Dam Safety Section

INTEROFFICE MEMORANDUM

TO: Lyle Swank, Eastern Region Office Manager
CC: Steve Bosworth, James Cefalo, Pam Skaggs
FROM: John Falk PE, Dam Safety Manager
DATE: March 18, 2015
SUBJECT: Reservoir Storage Capacity

Daniels Dam & Reservoir

Figure 1 – Area and Capacity Diagram; copy from design drawings prepared by W.H. Smith, P.E (1965). The diagram is printed on sheet 3/9. The design spillway crest is elevation 5262.5 feet, a value which equals or closely matches the existing USGS quadrangle datum (MSL).

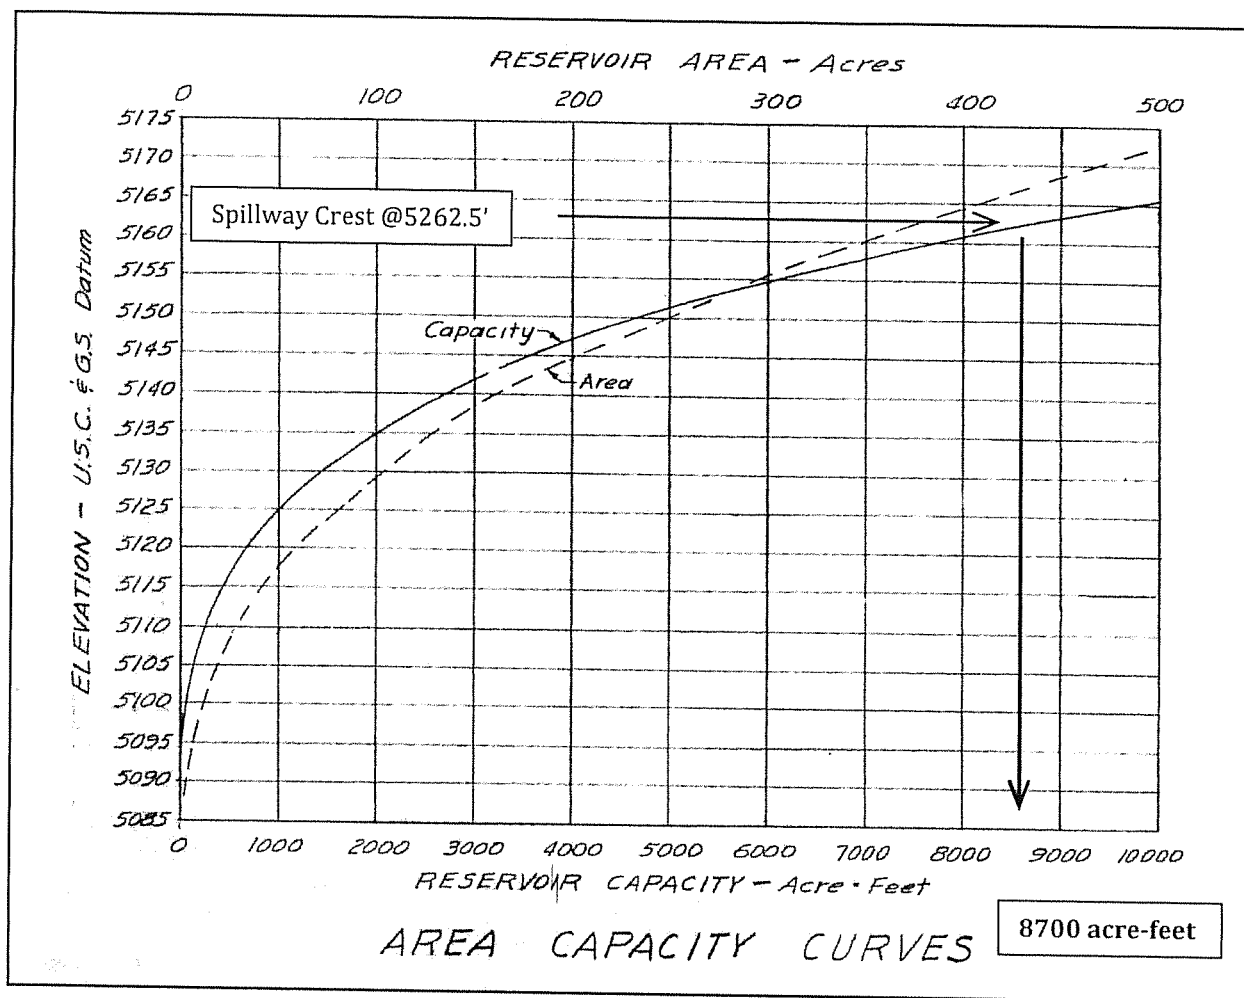
Permit R-1104 was issued to St. Johns Irrigation Company on 1/9/1962 for 9,500 acre-feet (AF) of storage; however Water Right License 15-2080 limits the reservoir storage capacity to 8,700 AF. This smaller value likely is based directly upon the 1965 design drawings (Figure 1). It's important to note that the total reservoir volume consists of two (2) water right storage components; one @ 8,075 AF allotted to irrigation, and a transferred amount equal to 625 AF that was originally dedicated to Elkhorn Dam located approximately 3 miles downstream. Elkhorn Dam was built in 1917, but was abandoned in the early 1950's due to the inability of the reservoir to hold water.

An independent estimate of storage capacity was performed by IDWR staff using height measurements (IDWR Dam Safety 2003) and surface area (2009 aerial photographs), from which the following equation was used to obtain an estimate for reservoir storage capacity at or near full-pool conditions:

$$\rightarrow 81.7 \text{ feet (hydraulic height)} \times 265.2 \text{ acres (surface area)} \times 0.4 \text{ (shape factor)} = 8,667 \text{ acre-feet}$$

This calculation is used only for comparison against the storage value included with the 1965 design drawings (Figure 1). In this instance, both values for water volume are similar. Therefore, because the design drawings correspond with the WR License, a storage value of **8,700 AF** is recommended to represent the storage capacity of the reservoir. Note that this "official" capacity value does not account for any deposition of sediment in the bottom of the reservoir that may have occurred since construction of the dam. Note also that the pool level in the reservoir is measured via a vertical steel tape in the gate house. The tape is reverse notation, i.e. the spillway crest is 13.5 feet, and each incremental decrease in the pool level corresponds to a larger number on the tape. Although unconfirmed, the intent of this accounting seems to have been to "zero" the tape at the dam crest.

Recommendation: Until such time an area/ capacity survey is performed by a licensed professional and submitted to IDWR Dam Safety for review and approval, the physical volume of water impounded by Daniels Dam measured at the spillway crest, elevation 5162.5 feet (USGS-MSL), is presumed to be 8,700 acre-feet. Note that this "official" value does not account for any deposition of bottom sediments in the reservoir that likely has occurred since the dam was constructed nearly 50 years ago.
